Permit Number: 081166

**City of Portland, Maine - Building or Use Permit Application**

Past Use: Single Family Home	Proposed Use: Single Family Home - Rough Second floor shell w/ stairs & decks	Permit Fee: \$520.00	Cost of Work: \$49,800.00	CEO District: 1
Proposed Project Description: Rough Second floor shell w/ stairs & decks		FIRE DEPT: <input type="checkbox"/> Approved <input type="checkbox"/> Denied	INSPECTION: Use Group: R3 Type: SB  IRC 2003  Signature: <i>Jm</i> 9/18/08	
		PEDESTRIAN ACTIVITIES DISTRICT (P.A.D.) Action: <input type="checkbox"/> Approved <input type="checkbox"/> Approved w/Conditions <input type="checkbox"/> Denied Signature: _____ Date: _____

**Dept:** Zoning      **Status:** Approved with Conditions      **Reviewer:** Ann Machado      **Approval Date:** 09/22/2008

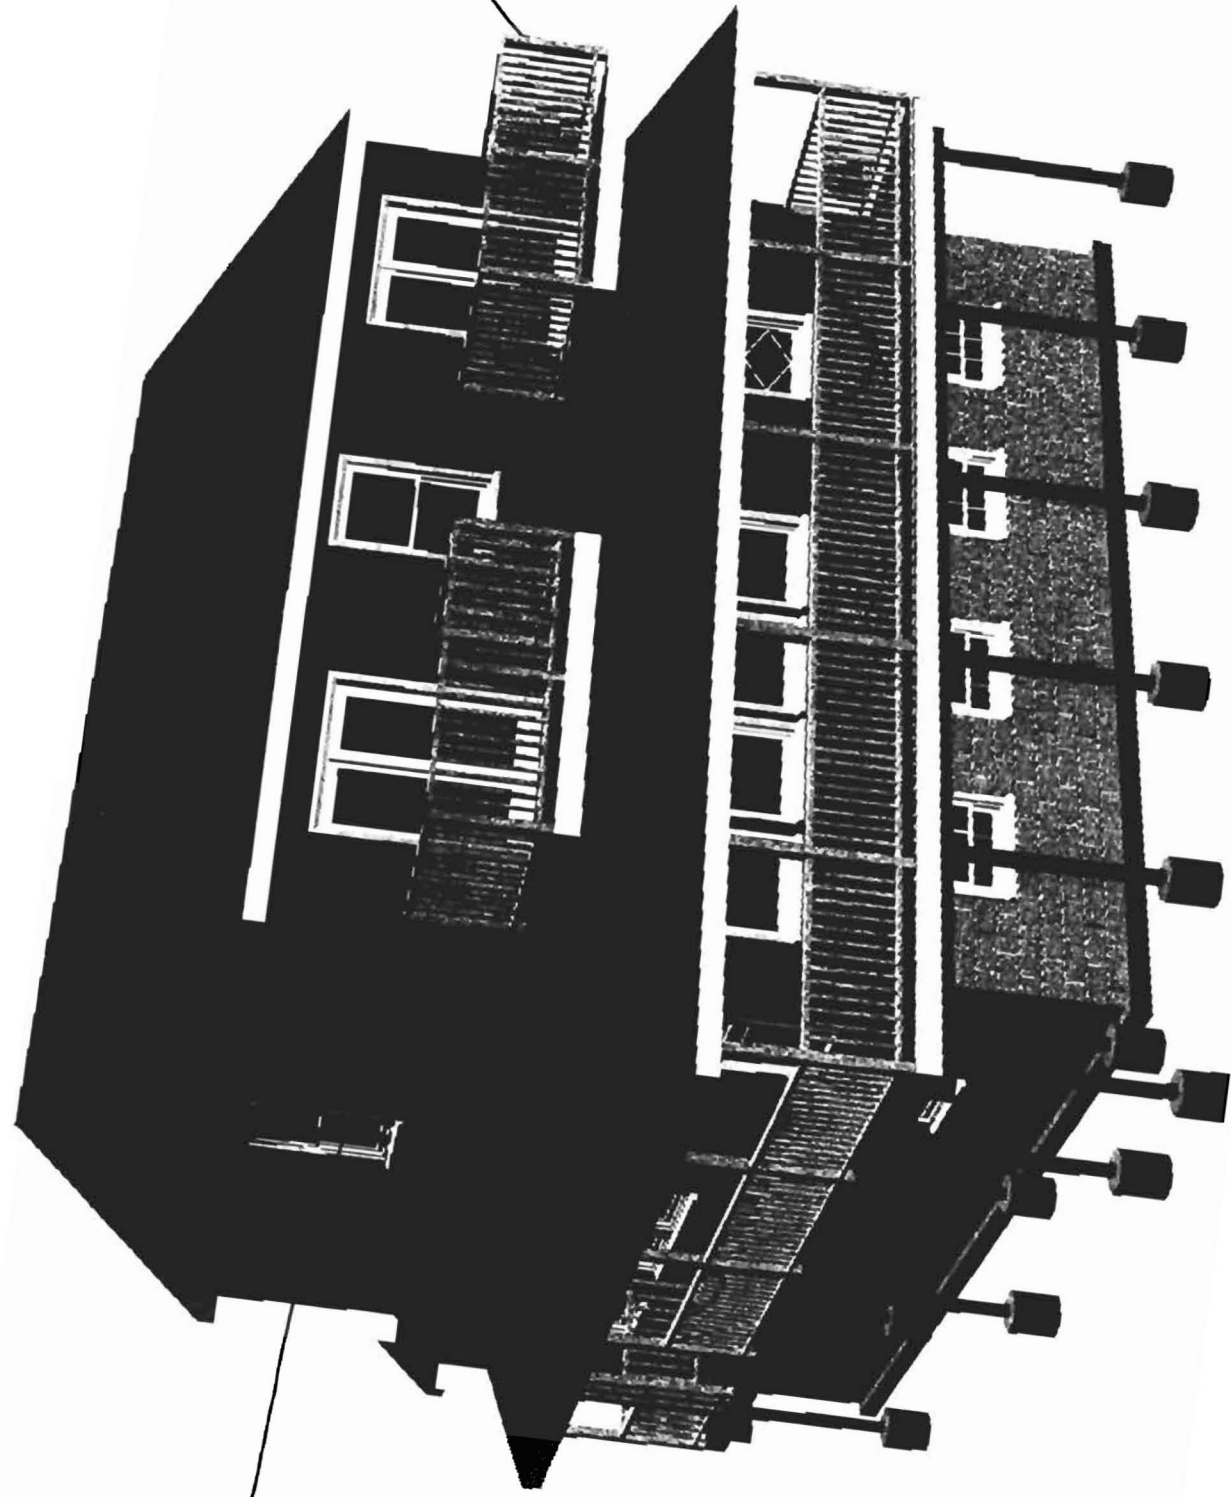
deck not  
part of permit.

part of  
permit  
deck not

**First Floor Plan**  
**(To Remain)**

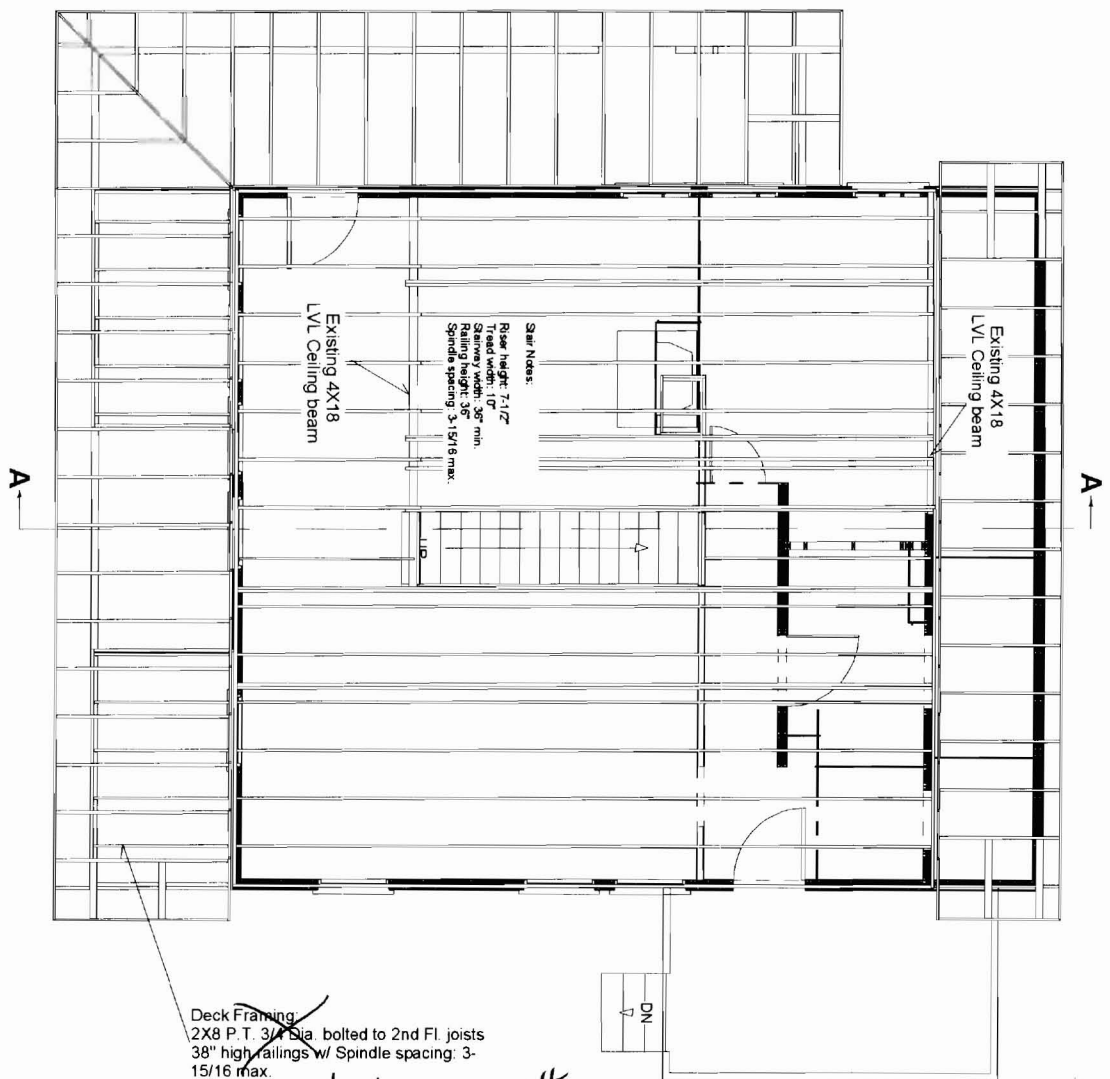
~~As noted~~  
 permit #  
 8-1359  
 for Deck

**Roof truss  
layout**

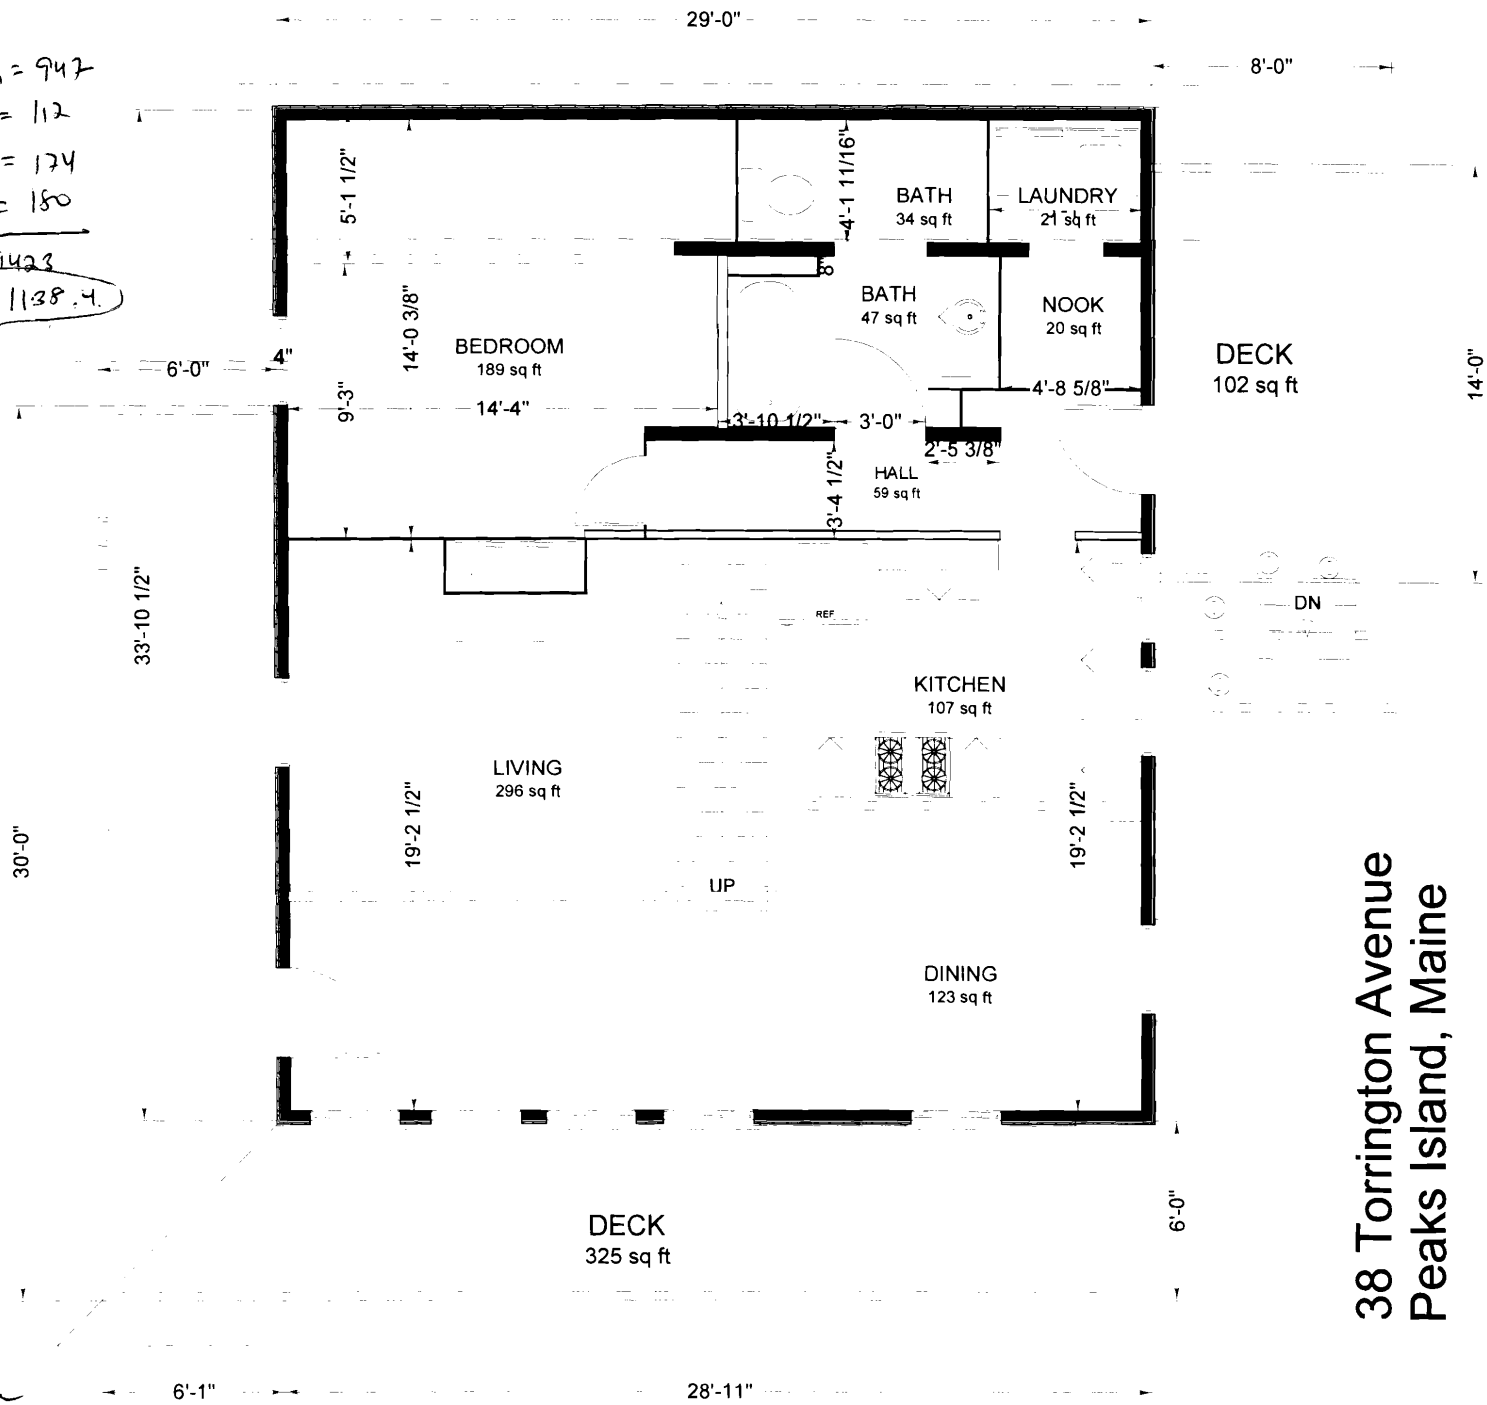
not in shoreland.

$$29 \times 29.61 = 858.69$$

$$- 394.55 \text{ (existing)}$$

464.14 increase

41% of allowable  
sq ft.

*Sketch Plan Depicting The Location Of High Water  
Made For*

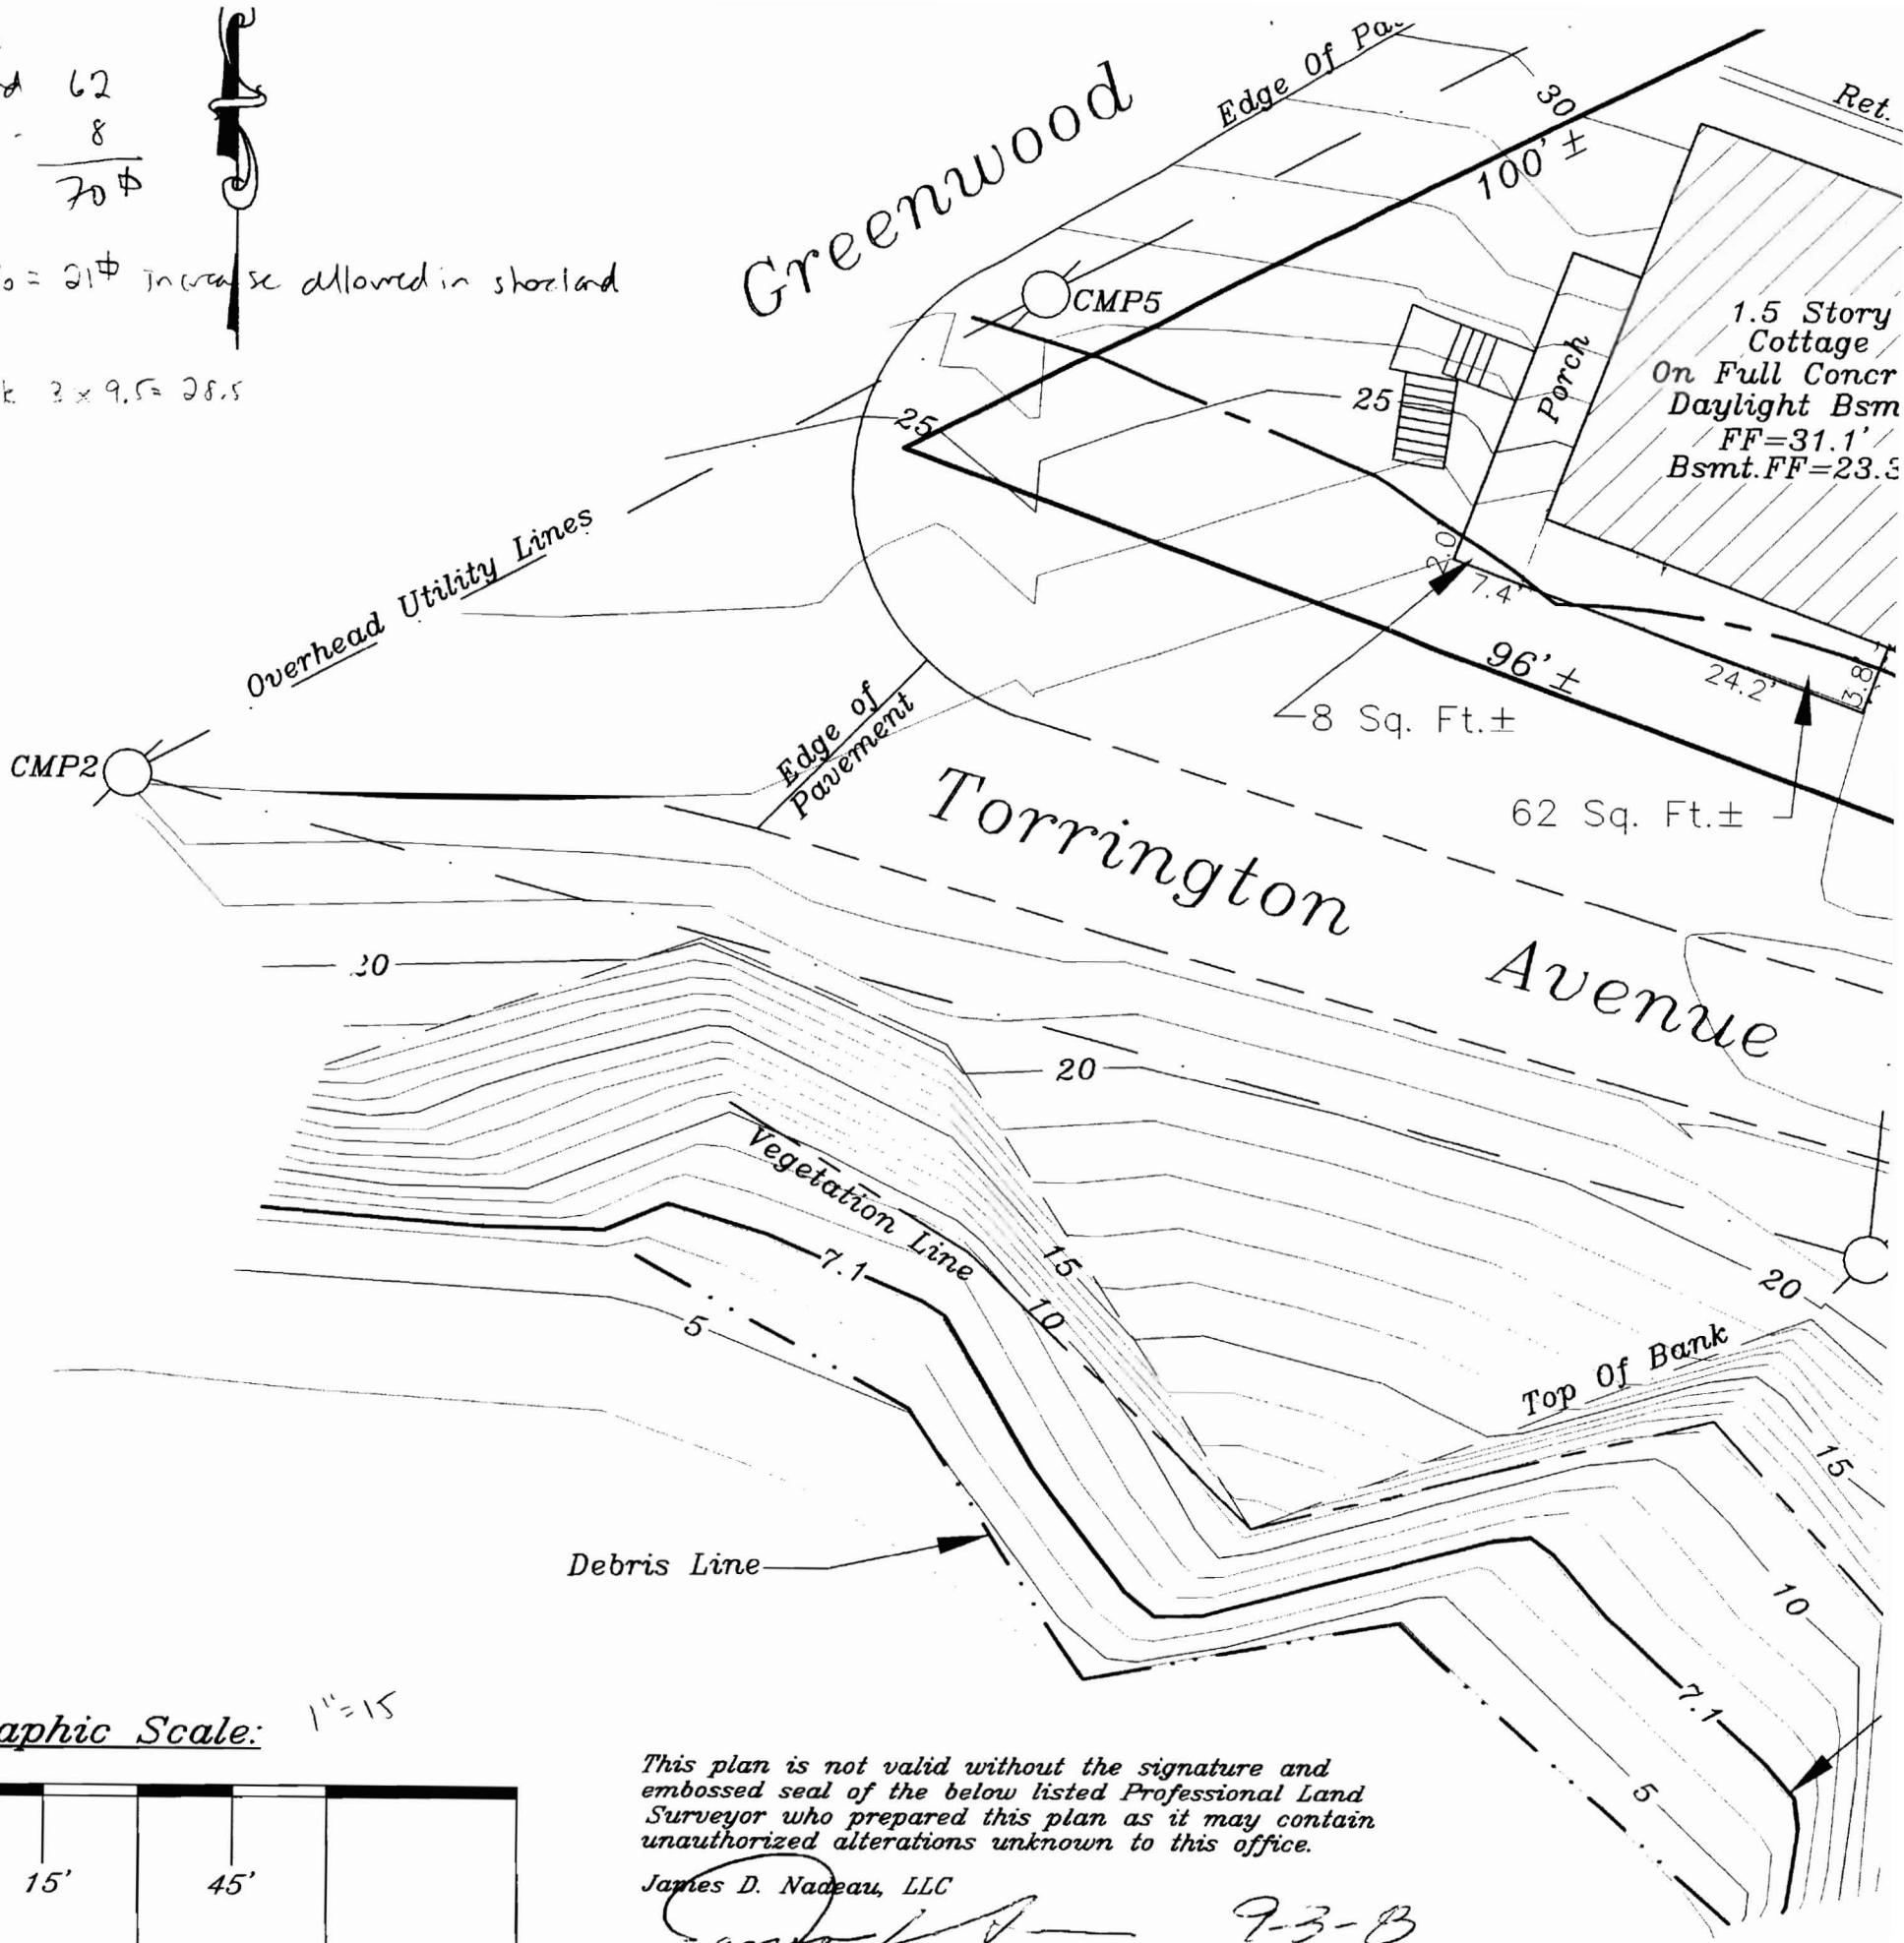
area in  
shoreland 62  
8  
70 ±

30% = 21 ± increase allowed in shoreland

right bank  $3 \times 9.5 = 28.5$
